SECOND SUPPLEMENTAL  
ENVIRONMENTAL CHECKLIST

Replacement Concrete Batch Plant and Construct Additional Aggregate Storage Bins with conveying system.

SUBJECT: Replies to Land Use Correction Sheet

PROJECT NUMBER: 8600636

PHOTO No. 6

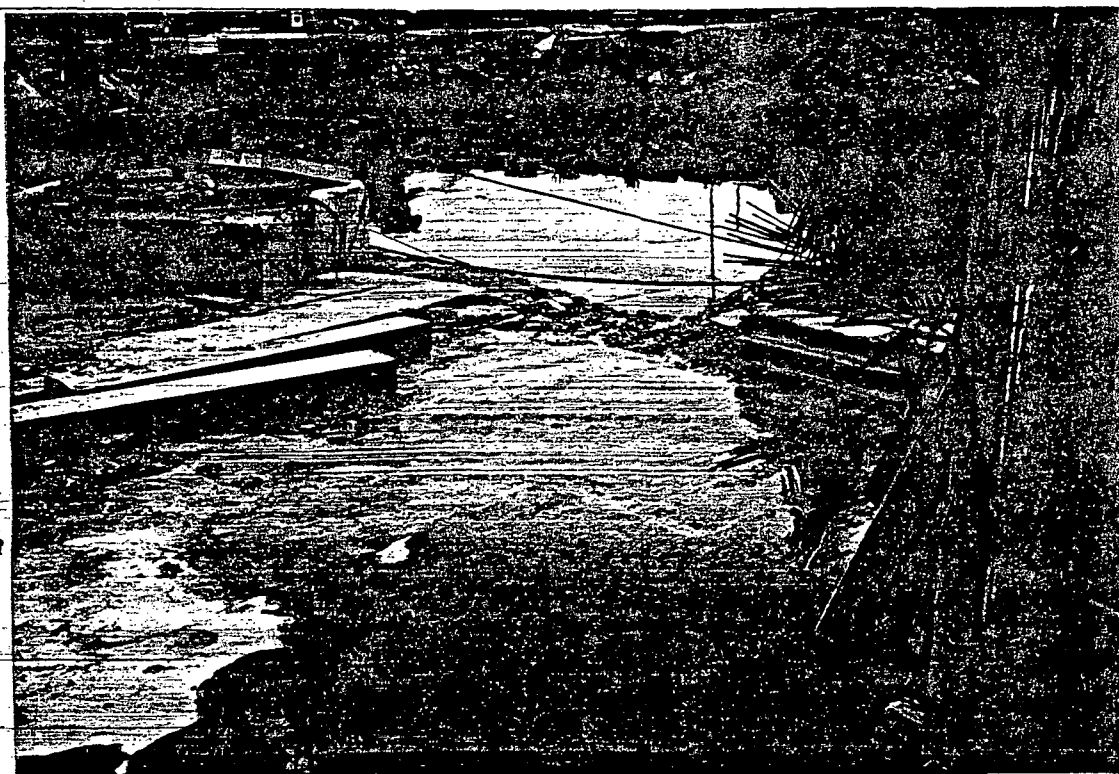
low spot

draining to

slip of Duwamish

PHOTO No. 10

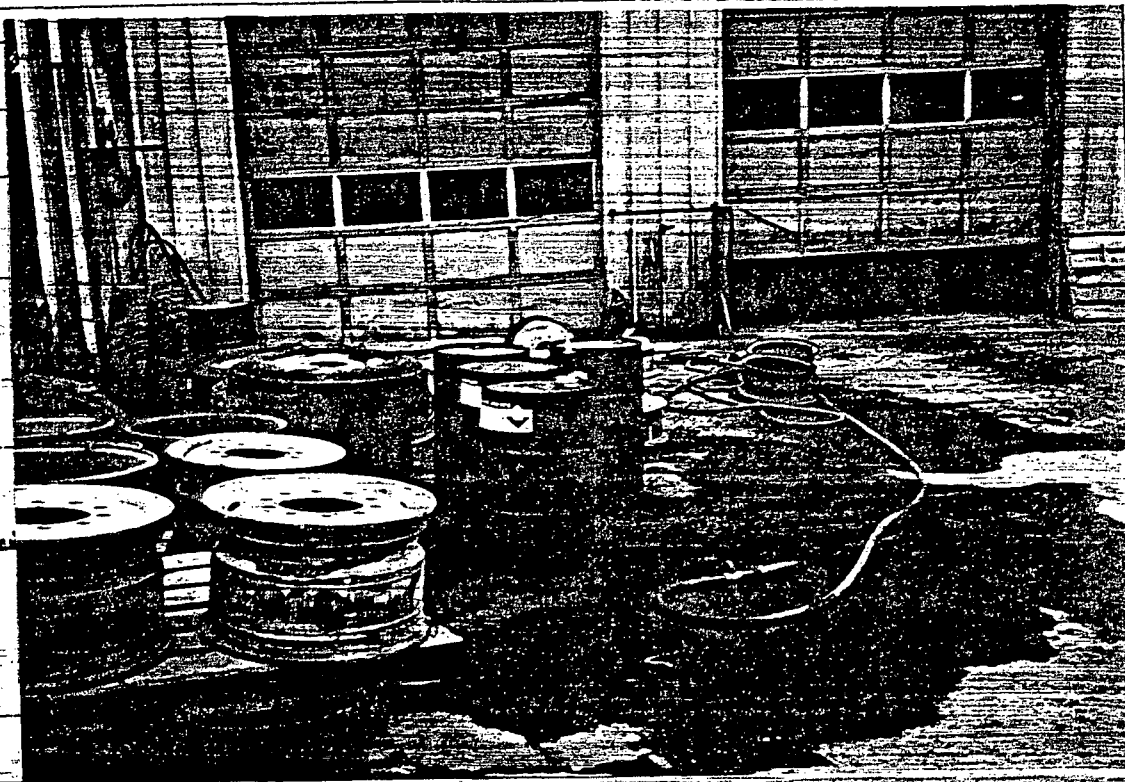
4 drums of  
Muriatic  
acid
